CITY OF ALBUQUERQUE

RE: Congress Apartments
Grading and Drainage Plans
Engineer's Stamp Date: 08/5/22
Hydrology File: C13D033

Based upon the information provided in your submittal received 8/5/2022, the Grading & Drainage Plan is not approved for Building Permit until the following comments are addressed:

CONGRESS APARTMENTS GRADING AND DRAINAGE PLAN

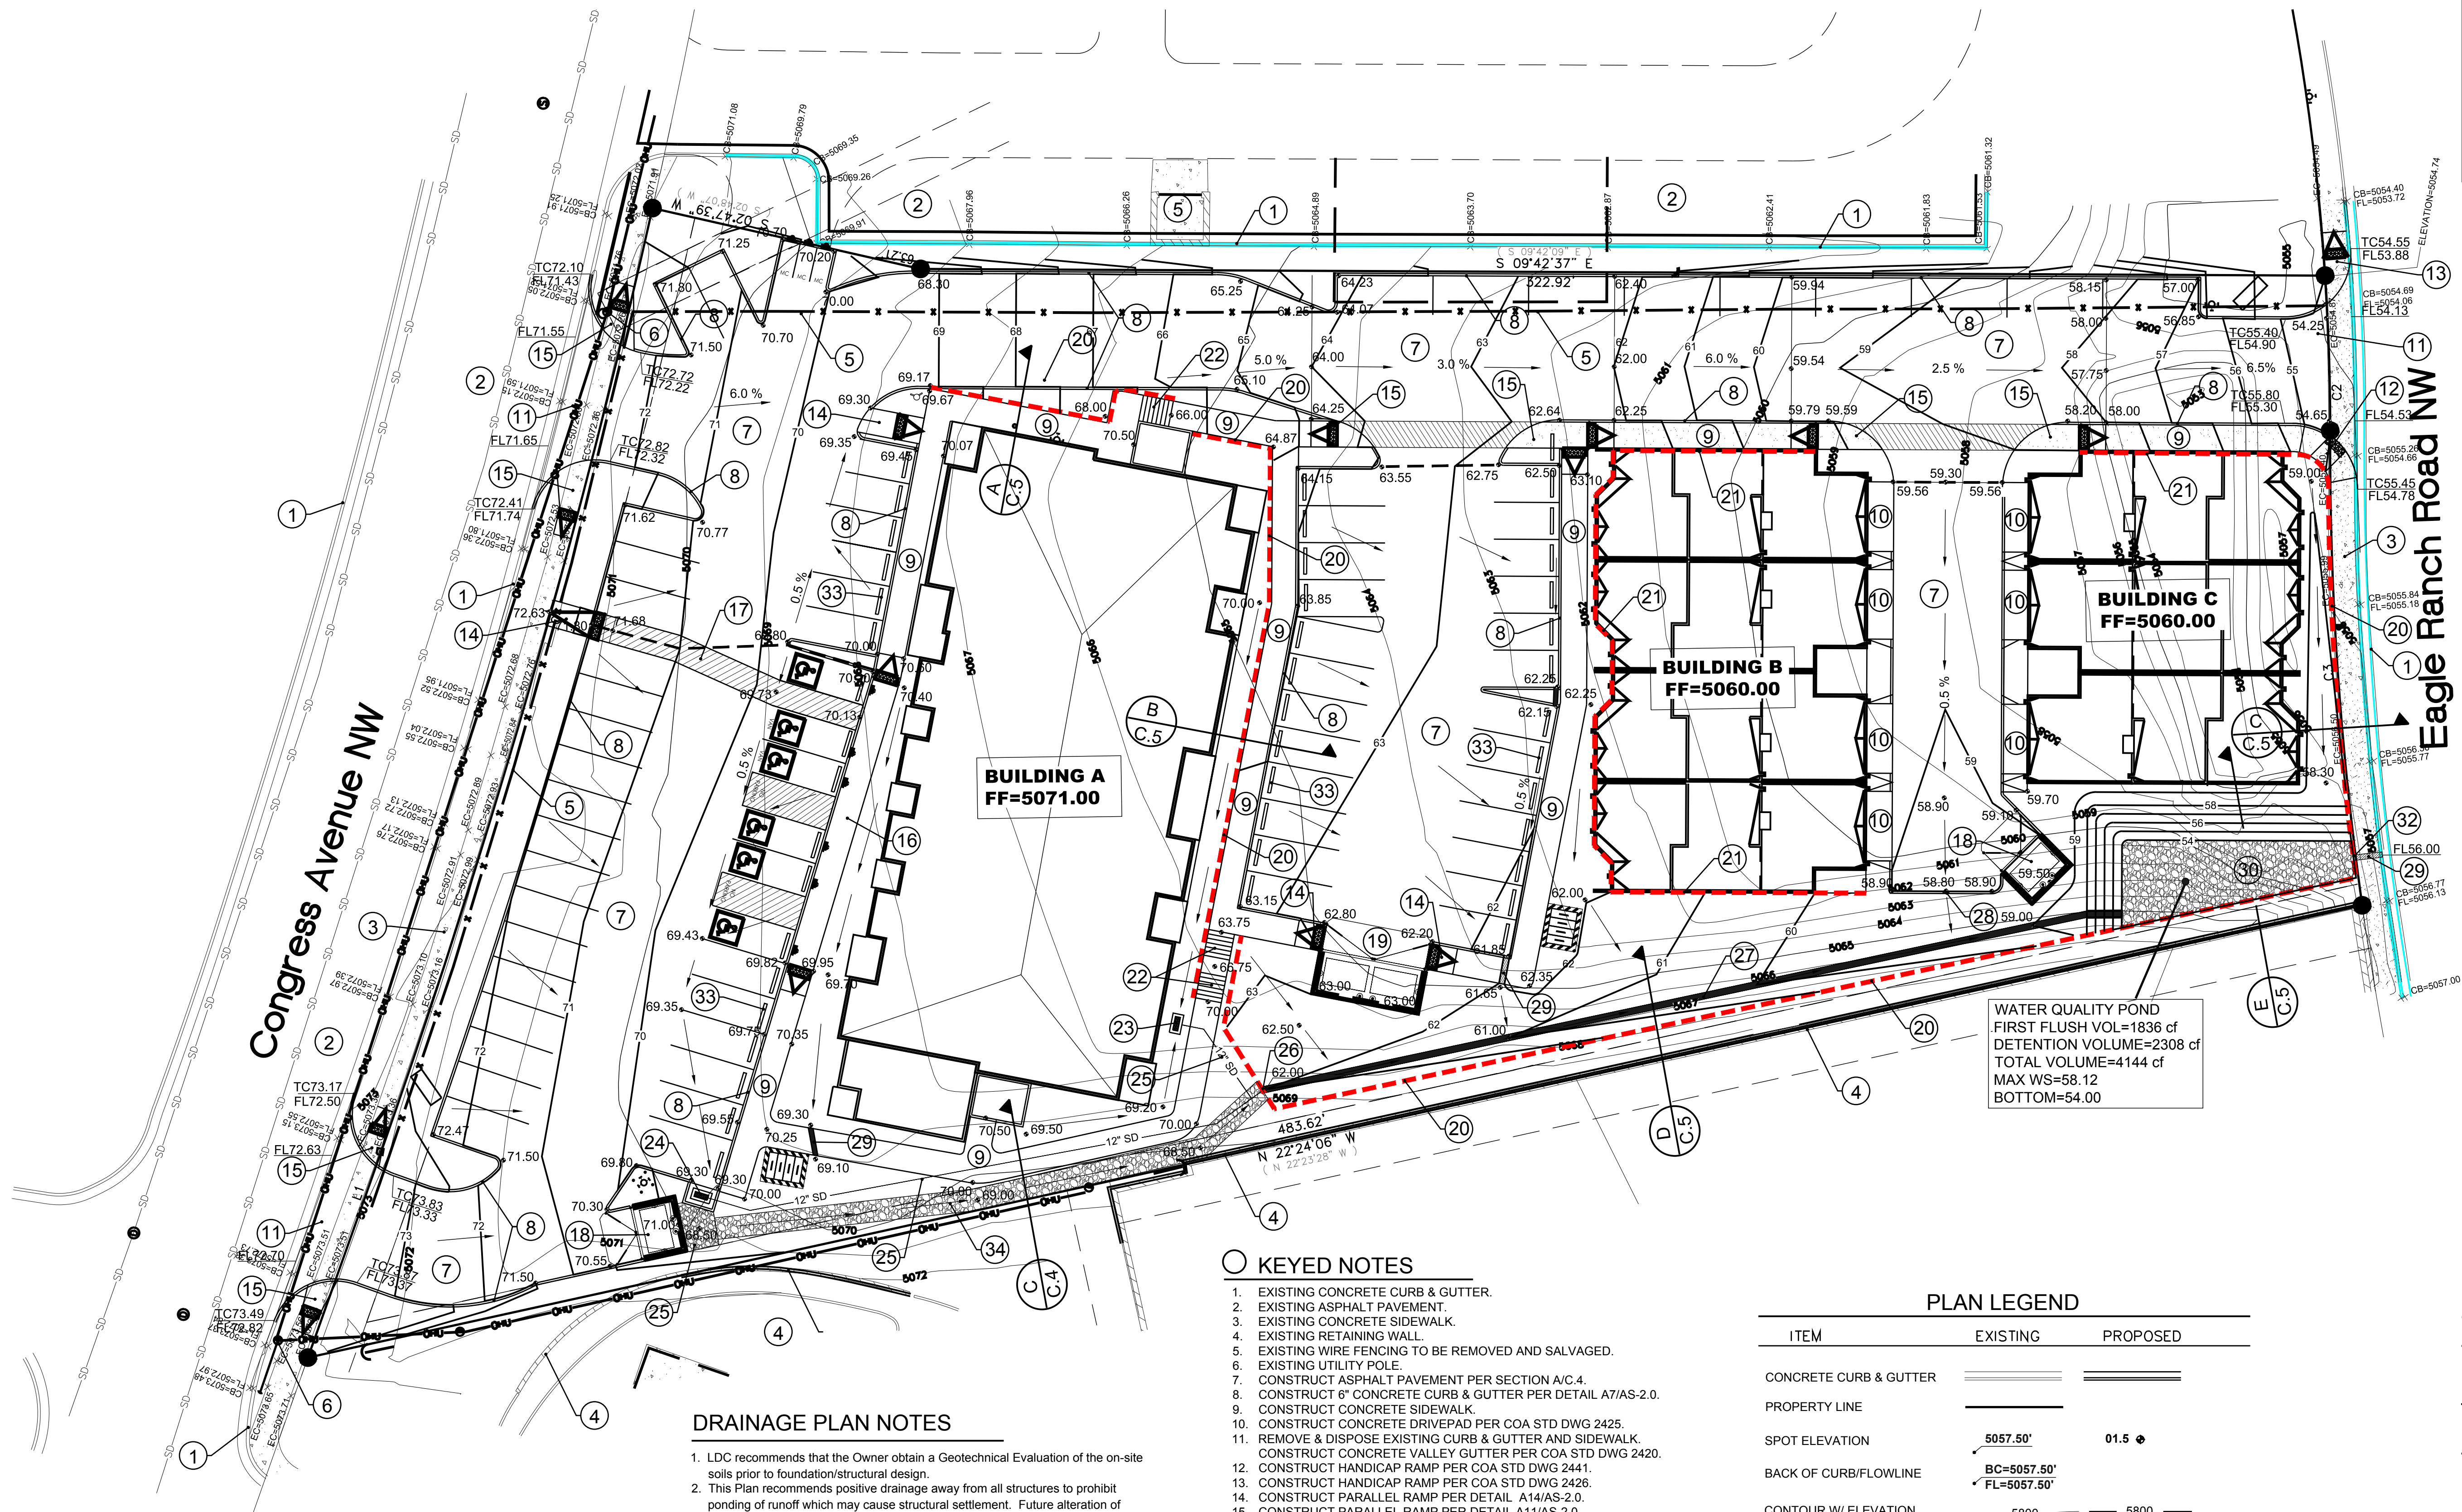
1. Provide stormwater quality for Basin A. The site appears to be too steep for ponding along the driveway, therefore it could be piped to the pond in the southeast corner or the drive entrance super-elevated so it is low on the south side. An inlet near Bldg B (59.79) would capture most of the flows from Basin A.

2. Due to the large scope of determining the downstream capacity in the Coors Blvd storm drain, it would be preferable for the proposed peak flow rate to not exceed the existing peak flow rate, however, due to site constraints the proposed discharge should be less than or equal to 5 cfs. To help reduce the discharge rate:

- a. The pond in the southeast corner could have vertical walls to increase the volume.
 - b. There is room for a pond south of Bldg B and south of the refuse containers between buildings A and B.

3. Pond comments in comment 2 above, would also help the site meet the first flush volume requirement.
4. To help the first flush volume infiltrate, the pond bottom could be amended (raked with bucket or similar).

5. Provide the invert where the 12" storm drains connect.

6. On the retaining wall plan , provide TW/BW rather than TW/FG as sometimes FG grade is higher and lower than the TW grade.
7. What is the significance of the linework that juts into the drive north of the parking area between buildings B and C?
8. For Sections B, C, D and E on Sht C.4 provide the depth of the invert in the landscape area.
9. Pond slopes are to have aggregate. This comment may be moot per comment 2.a.
10. From reviewing contours in our GIS, it appears that north-bound Eagle Ranch Rd is lower than south-bound Eagle Ranch Rd. Please confirm with spot elevations at the northbound flowline to justify not providing the standard water block of 0.87 inches at the property line.
11. Please increase the font size for the First Flush Criteria.
